April 01, 2025

- To: All Bidders
- Re: College Heights Elementary School Asphalt Replacement, Striping & Play Equipment Poles & Foundation Installation – Addendum No. 01

+       +	Addendum 1 Attachment P.1	Alternates 1 & 2
+       +		PAVEMENT REPLACEMENT PLAN COLLEGE HEIGHTS ELEMENTARY SCHOOL SLURRY AREA
y & Base Section per Construct or Replacement of Existing Par y Section in this Area 0.333 Section in this Area 0.5		SNOISYAH DATE 03/14/2025 PA JOB No. 3350 SHEET OF 4 SHEETS

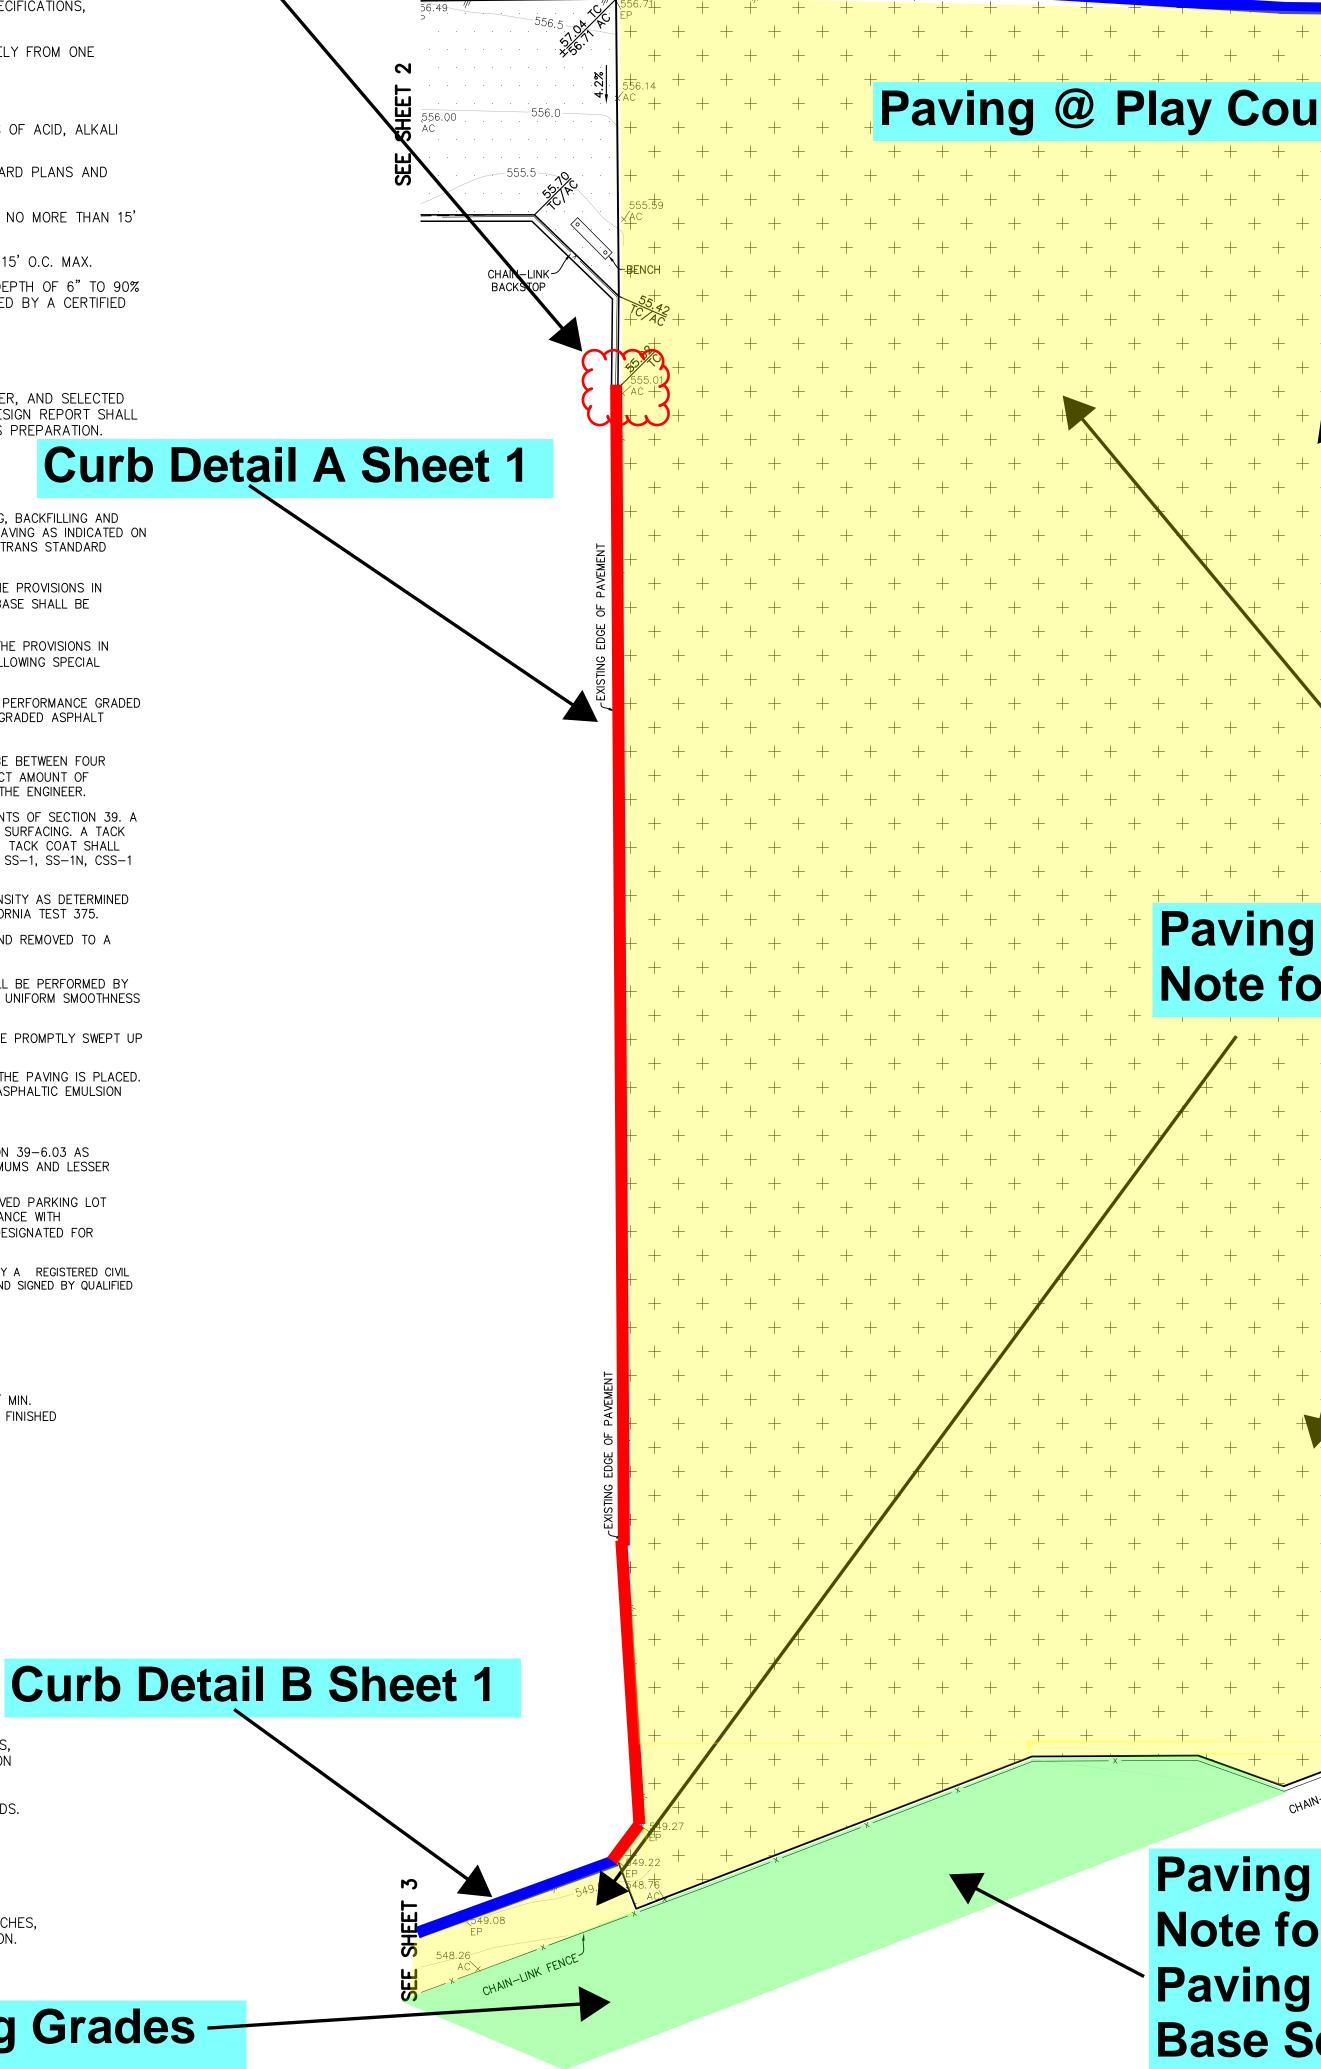
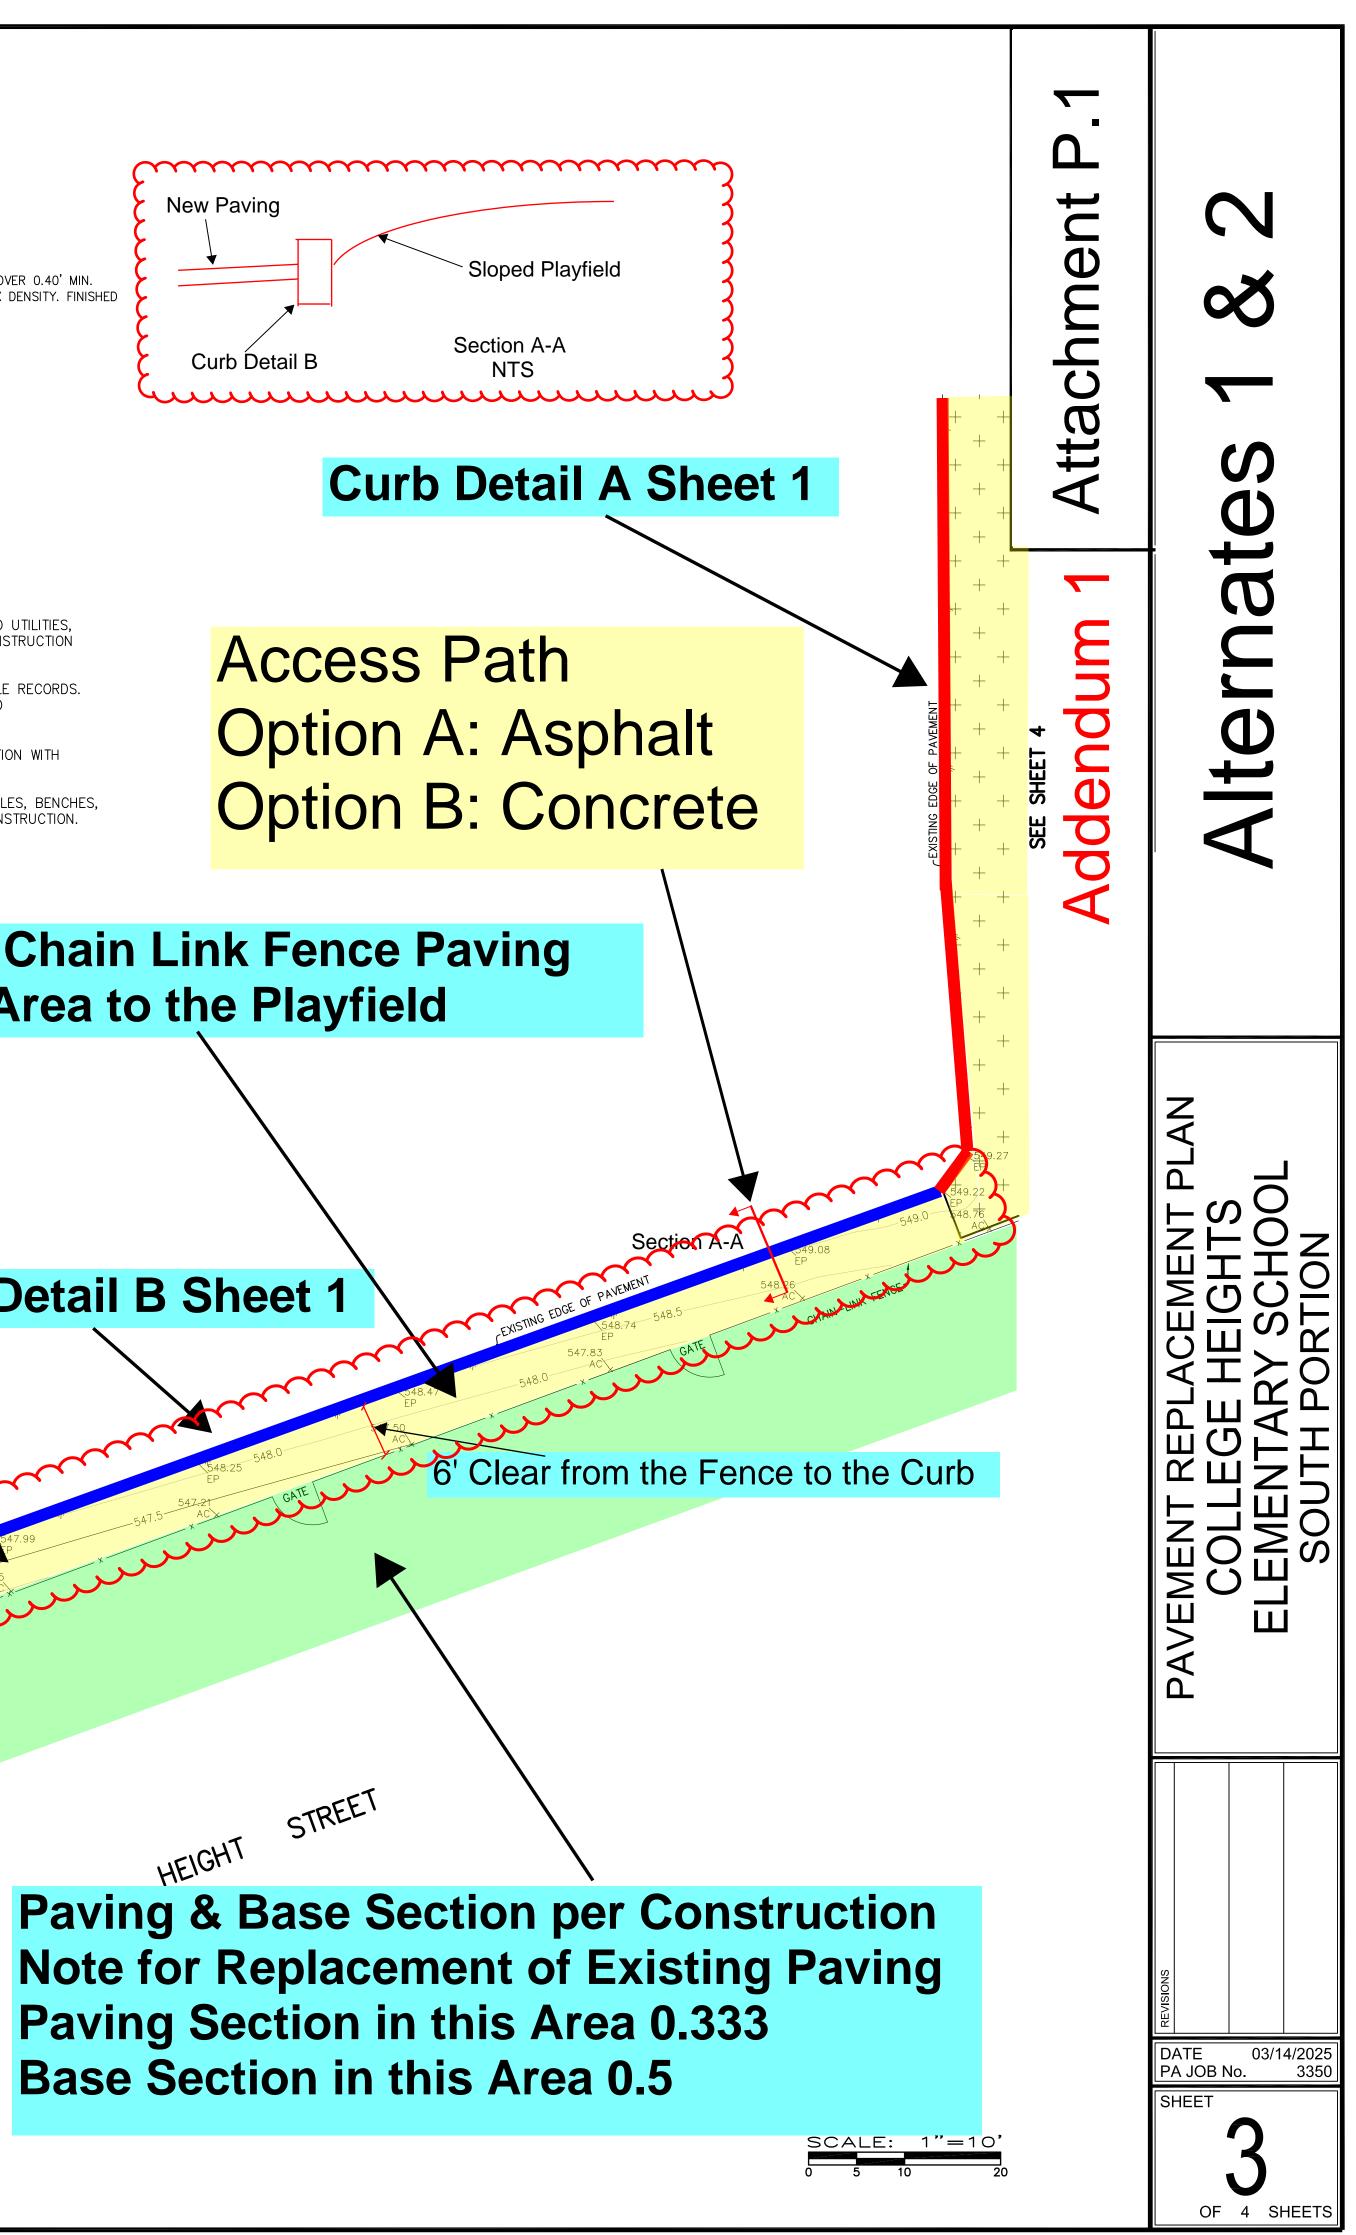
- 6. Bid Package 03 will re-install play equipment per the details provided.
  - 7. Options for the student access path at the south end of the project along the chain link fence:

- Option A
      - Provide an asphalt path for the Alternates 1&2 drawings. Increase the path to 7-6" from the chain link fence to the inside face of curb.

- Option B
      - Provide a 4" concrete path in lieu of an asphalt path as shown on the Alternates 1&2 drawings. Path width to be 5'-6" from the chain link fence to the inside face of curb. Include reinforcing steel 18" o.c. longitudinal and transverse. Follow the concrete specifications on the plans.
